Memo to the Planning Commission

HEARING DATE: AUGUST 30, 2018

Date: August 30, 2018
Case No.: 2017-014841CUA
Project Address: 655 Alvarado Street
Zoning: RH-2 (Residential-House, Two-Family)
40-X Height and Bulk District
Block/Lot: 2803/028C
Project Sponsor: John Kevlin
Reuben, Junius & Rose, LLP
One Bush Street, Suite 600
San Francisco, CA 94104
Staff Contact: Jeff Horn – (415) 575-6925
jeffrey.horn@sfgov.org

Request #1 from 661/663 Alvarado St neighbors

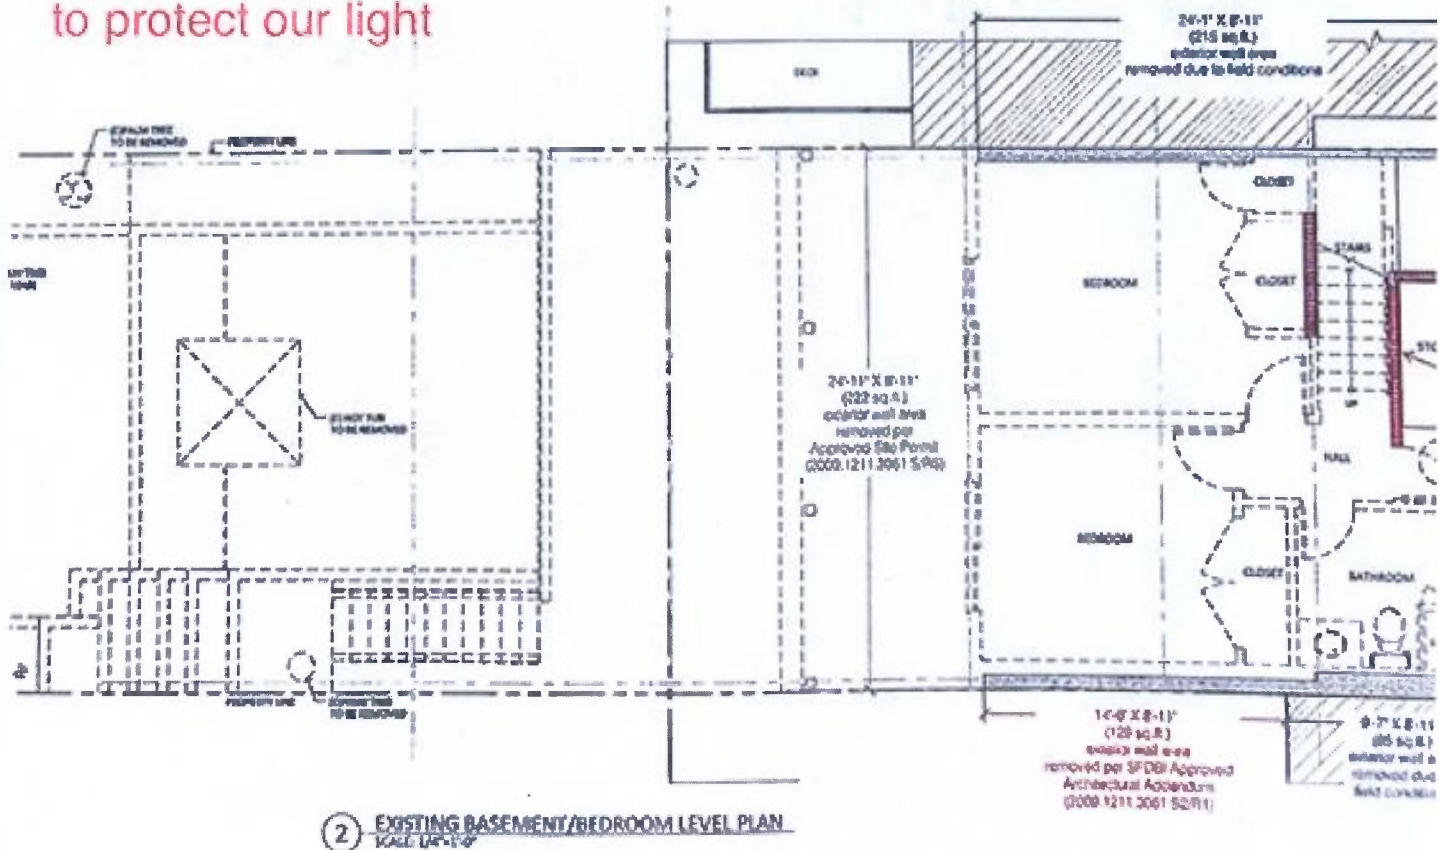
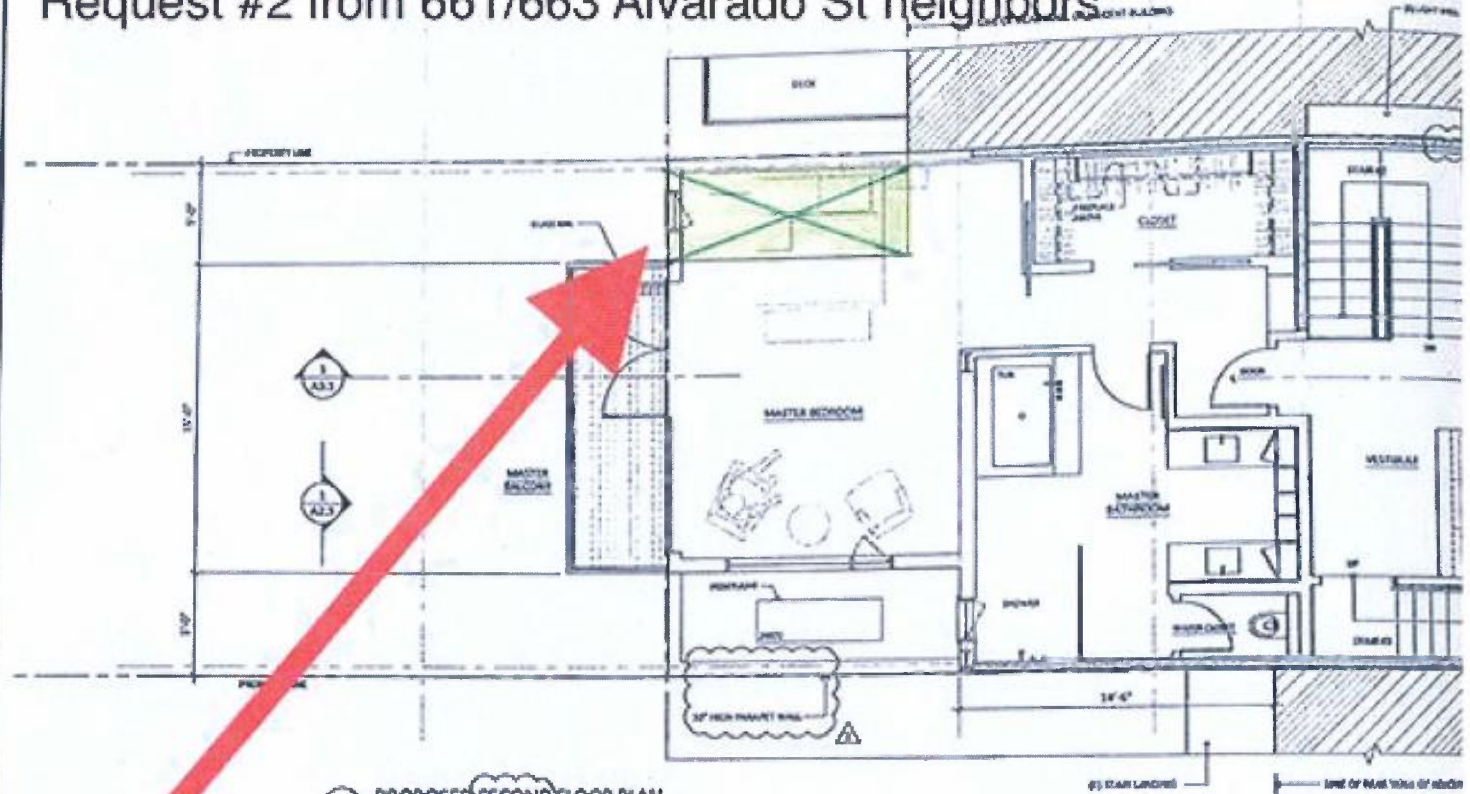
Proposed First Floor:
Please have SETBACK of 5 feet from property line
to protect our light

1 PROPOSED SECOND FLOOR PLAN
SCALE 1/8" = 1'-0"

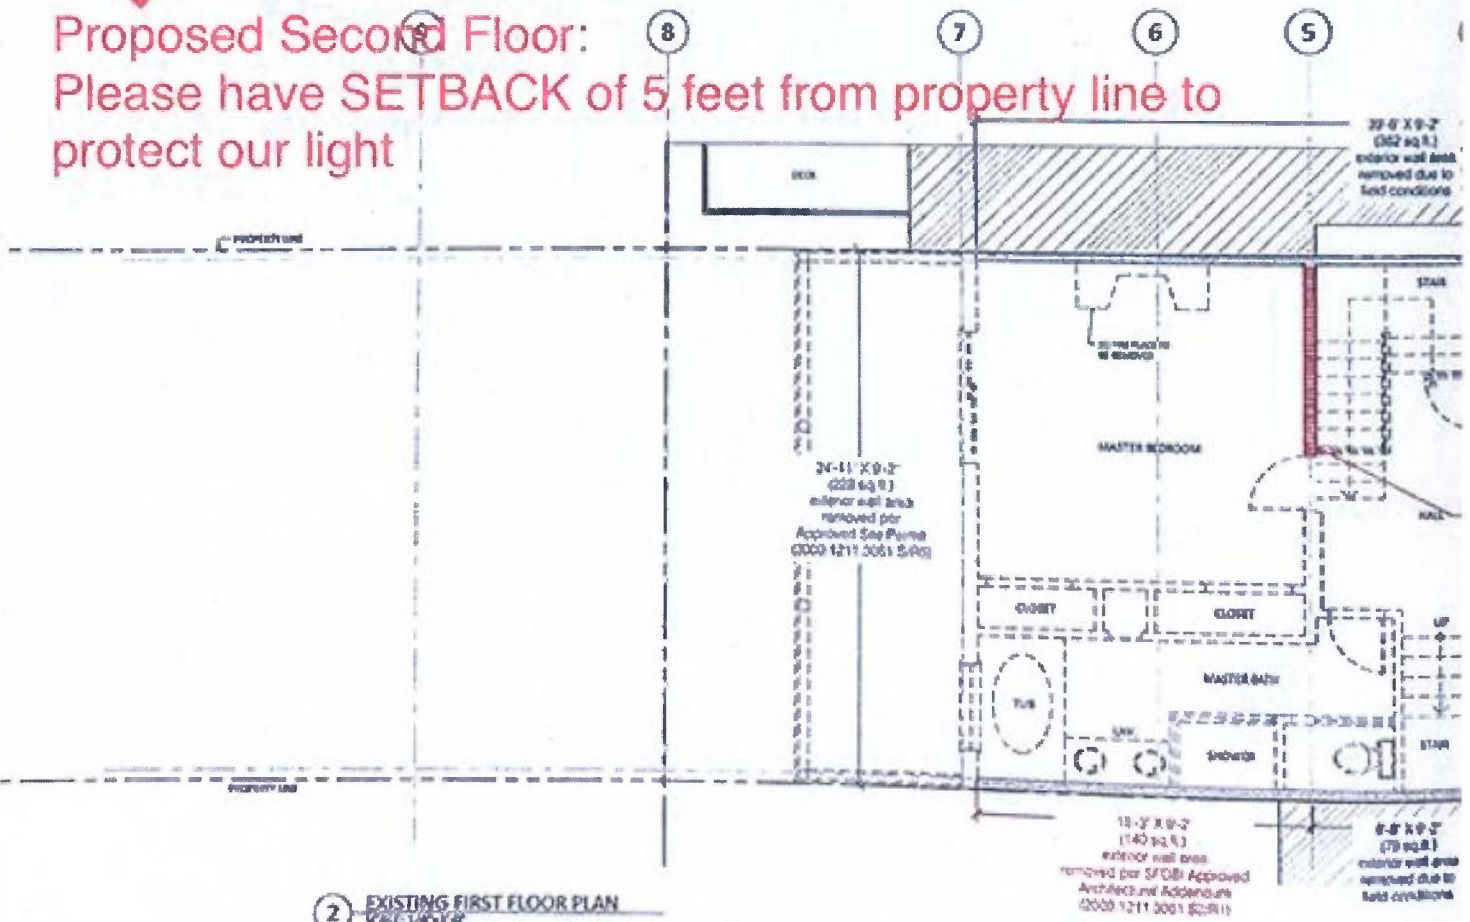
Proposed Second Floor:
Please have SETBACK of 5 feet from property line to
protect our light

Request #3 from 661/663 Alvarado St neighbors

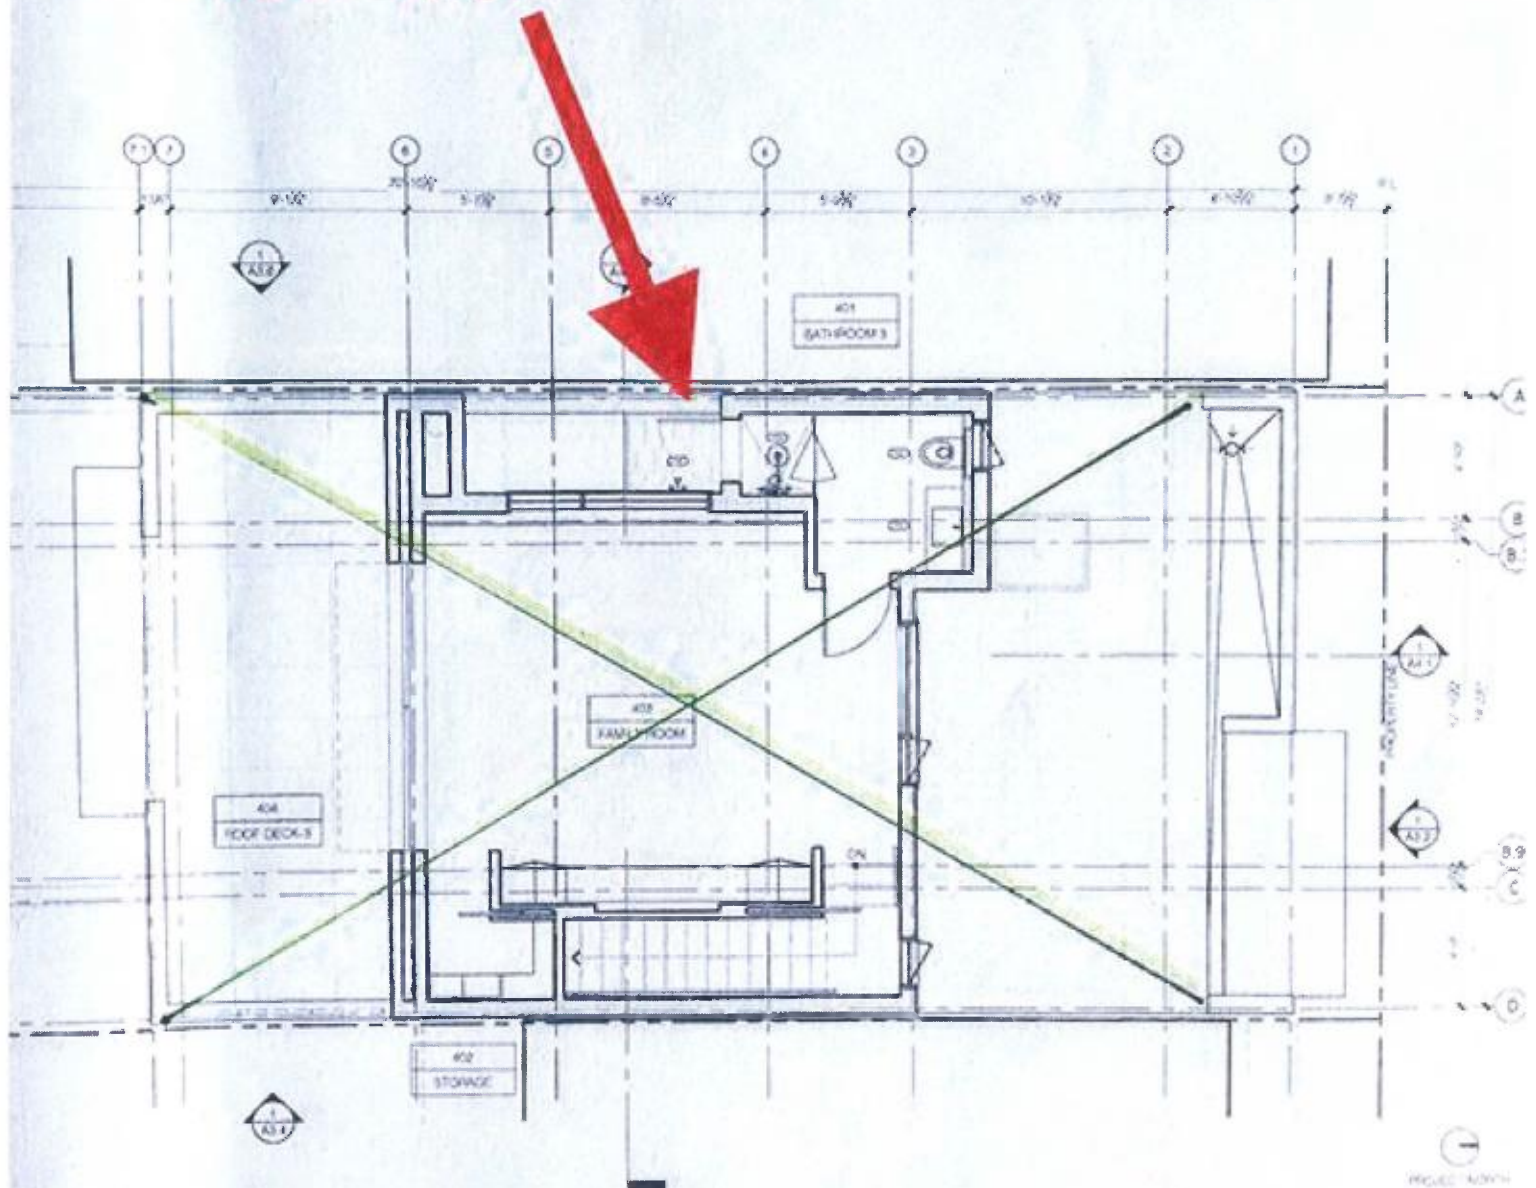
Proposed Fourth Floor/ Top Floor:
Please remove the top floor to protect our privacy
- it has a door thru the bathroom that access to
outdoor path that overlook our roof into our house
thru our skylight
